DEVIATION REQUEST AND DECISION FORM

Project Name : Rising Moon	Date: 11/1/2024
Schedule No.(s) : 5503101010	
Legal Description : TRACT B MORNING SUN I

DEVIATION REQUEST (Attach diagrams, figures, and other documentation to clarify request) REVISED 2-12-2025

Rising Moon (LSC# S244050)

Deviation Figure 1
**Subject Intersection Approaches/Street
Segments for Requested Deviations**

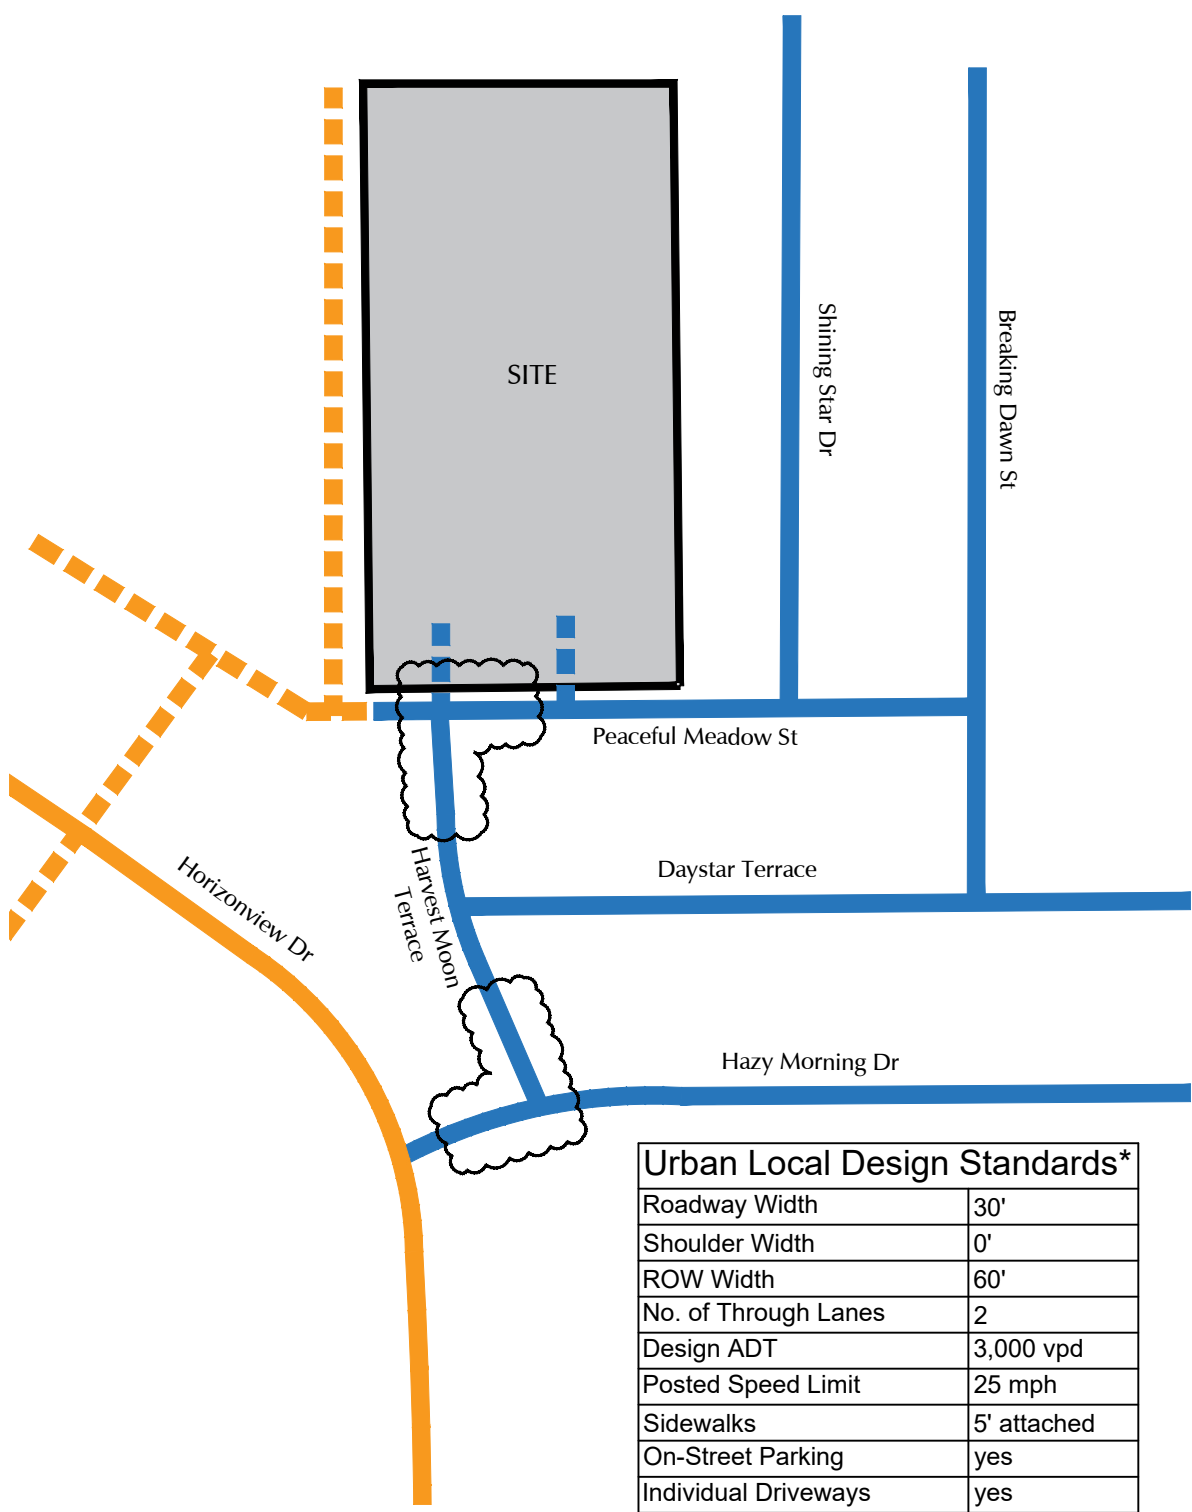
Exclusive Right Turn Lanes Required: A deviation from the standards of or in Section 2.3.7.D.2 of the Engineering Criteria Manual (ECM) is requested. The request is NOT to add exclusive right-turn lanes for right turning movement volumes which exceed and/or are projected to exceed 50 vehicles per hour (vph). at the intersections of Peaceful Meadow Street/Harvest Moon Terrace and Hazy Morning Drive/Harvest Moon Terrace.

Exclusive Left Turn Lanes Required: A deviation from the standards of or in Section 2.3.7.D.1 of the Engineering Criteria Manual (ECM) is requested. The request is NOT to add exclusive left-turn lanes for right turning movement volumes which exceed and/or are projected to exceed 50 vehicles per hour (vph) at the intersections of Peaceful Meadow Street/Harvest Moon Terrace and Hazy Morning Drive/Harvest Moon Terrace.

Please refer to Deviation Figures 1 and 2, which depict the location of the subject intersection approaches/street segments, Deviation Figure 2 also shows the County roadway classification of the subject streets. Deviation Figure 3 shows details of the existing/projected turning movements associated with this deviation. Deviation Figure 4 presents a copy of the County standard cross section for the subject streets with LSC notation added to show that even if auxiliary turn lanes were operationally necessary (which they are not), there would be physically no street width available for the addition of auxiliary turn lanes.

This request has been determined to have met the criteria for approval. A deviation from Section 2.3.7.D.2 & 2.3.7.D.1 of the ECM is hereby granted based on the justification provided.

Deviation Figure 4

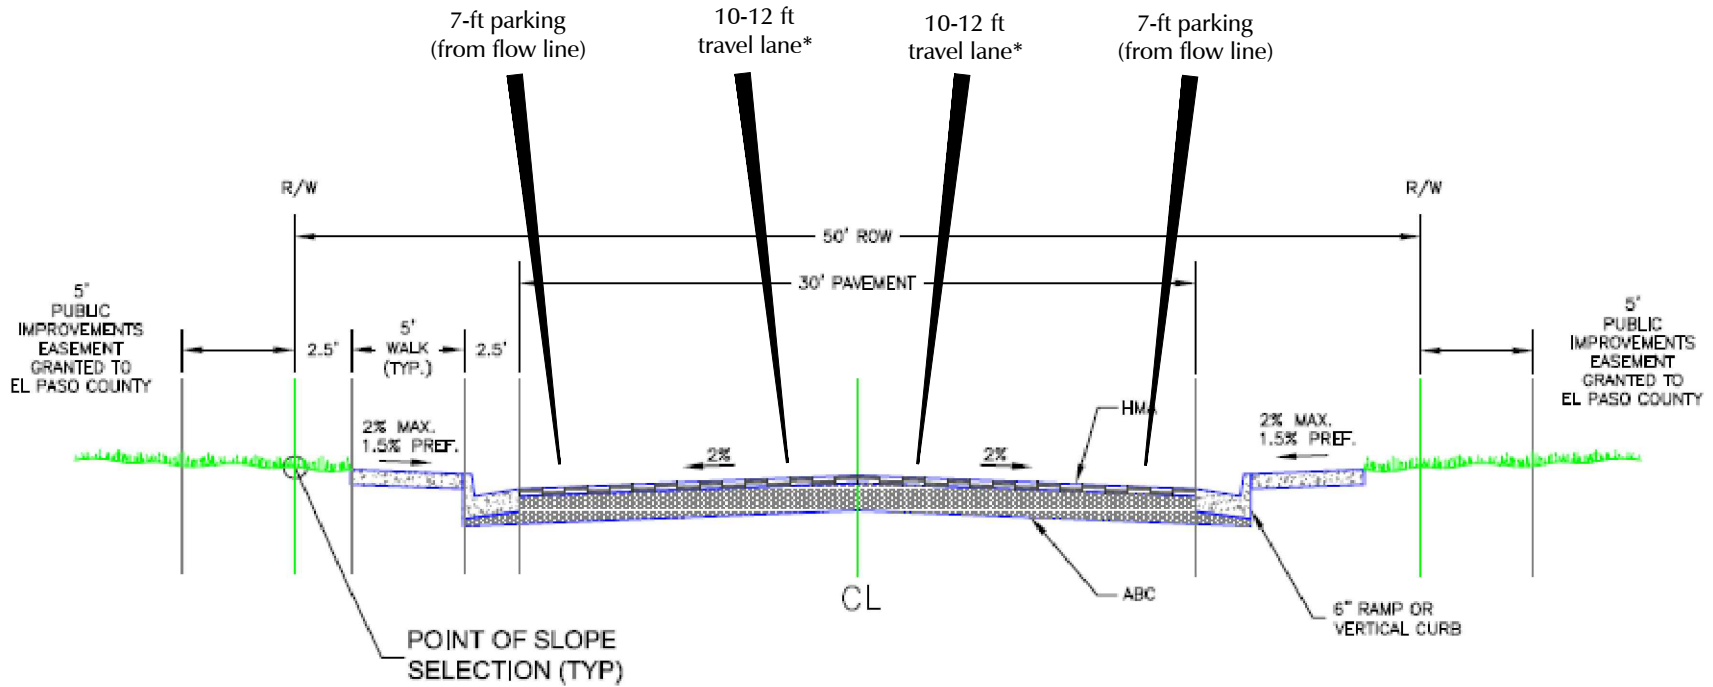
Also, there is not sufficient ROW. Deviation Figure 4 presents a copy of the County standard cross section for the subject streets with LSC notation added to show that even if auxiliary turn lanes were operationally necessary (which they are not), there would be physically no street width available for the addition of auxiliary turn lanes.

* 12' is the ECM standard land width, 10' one-half the remaining width less assumed two 7' on-street parking lanes. The total is 34' with not available width for auxiliary lanes.
